Application Number: 10/783,812
Filing Date: February 20, 2004
Appellant(s): GAMMON, BARRY

EXAMINER'S ANSWER

This is in response to the appeal brief filed January 09, 2006 appealing from the Office action mailed July 21, 2005.

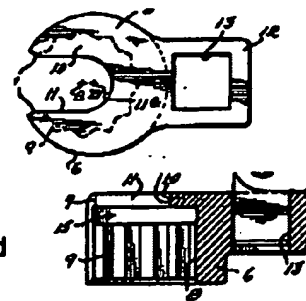
Claims 1 and 2 (as best understood) stand rejected under 35 U.S.C. 102(b) as being anticipated by Johnson, US Patent No. 2,715,347.

Johnson discloses all the limitations, i.e., a socket having a center line (B) and a perimeter (Fig. 3), first face (bottom face as shown in Figs. 2 and 4), an opposite second face, and a receiving slot extending from the first face towards the second including a receiving region (8) adjacent to the first face (first face separated from the second face by web 10) having a center line (A) offset from (B) and includes a step (defined by 10 or 15) against which the connection element rests during rotation of the socket body, and wherein the second face includes a port (13) that does not extend to the first face, having a center line that is not in alignment with the socket body positioned within the perimeter of the socket body.

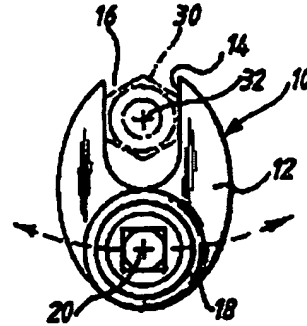
Claims 1-6 (as best understood) are rejected under 35 U.S.C. 103(a) as being unpatentable over Higgins (GB 2 266 257) in view Farnan et al.

Higgins meets all the limitations of the claim 1, i.e., a socket having a center line and a perimeter, first face and an opposite second face, and a receiving slot extending from the first face towards the second including a receiving region adjacent to the first face having a center line that is not in alignment with the centerline of the socket body (Fig. 1) and wherein the second face includes a port (24) that does not extend to the first face of the socket body, the port having a center line that is not in alignment with the center line of the socket body, except for a step against which the connection element rests during rotation of the socket body. Farnan et al. teaches stepped polygonal configurations having wing slots. It would have been obvious to one of ordinary skill in the art, at the time the invention was made, to modify the invention of Higgins with the polygonal stepped configuration and wing slots as taught by Farnan et al. to adapt the tool for driving different sized fasteners and fasteners having wings.

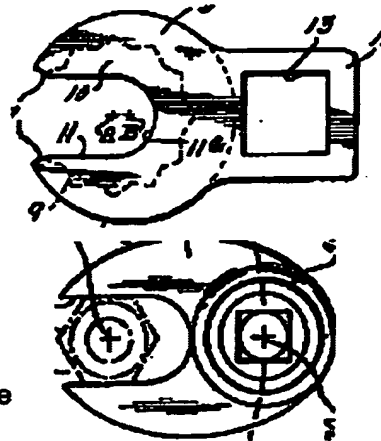
In response to the argument against anticipation, Appellant argues that the port in Johnson is not part of the body, and states that the port is in the handle section and not the head proper or box portion 5 of the wench head. This argument fails to indicate which part of the claim limitations are not met. Whether Johnson discloses an inferior design or not does not further limit the tool as claimed. At best it appears, Appellant reads more into the "body" than recited. Claim recite for the body to have a center line and a perimeter, a first face, an opposing second face and a receiving slot extending from the first face to the second face...the socket body includes a step against which the workpiece rests...and wherein the socket drive port is positioned within the perimeter of the socket body and does not extend above the first face.

Lackign structural limitation and relationship and or clear definitions of the elements, the socket of Johnson meets the "body" as recited. The fact that the port is located on "handle receiving shank" as argued by Appellant, does not exclude the reference, as it appears that Appellant is arguing for the shape of the body, without such limitations recited in the claim. In fact Higgins was cited to emphasis this point, that the port is part of the body.

With regards to the argument that the driver port of Johnson is not the same, because the port in Johnson is through and through, again Appellant is arguing features not recited in the claim. The limitation regarding the port is that it does not extend through to the first face, which is met by the port as disclosed by Johnson. The second face of the socket (the upper surface as

shown here) includes a port (13), which does not extend to the first surface (the lower surface shown here).

FIG. 2.

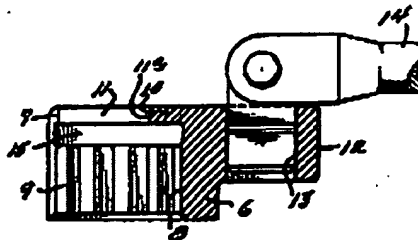
A socket for rotatably loosening or tightening a connection element, the socket comprising a socket body having a centerline (the body has an infinite number of "centerlines", e.g., B which is a lateral center on a line dividing the body symmetrically in half widthwise, or a centerline on a longitudinal line which would be

offset from B towards the port, here B was noted by the Examiner to meet this limitation), a first face (lower surface of cavity as shown here), an opposing

second face (upper surface) and a receiving slot

(cavity 8) extending from the first face to the

second face, wherein the receiving slot includes a receiving region adjacent to the first face for

receiving and capturing therein the connection element, the receiving region having a centerline (A) that is not in alignment with the centerline of the socket body (e.g., Fig. 3) and includes step (defined by 10 or 15) against which the connection element rests during rotation of the socket body, wherein the second face includes a socket driver port (13) therein that does not extend through to the first face of the socket body (as shown here, extends to a third face but not the first), the socket driver port having a centerline that is not in alignment with the centerline of the socket body (e.g., Fig. 3, shown here), and wherein the socket driver port is positioned within the perimeter of the socket body and does not extend above the first face (e.g. Fig. 2).
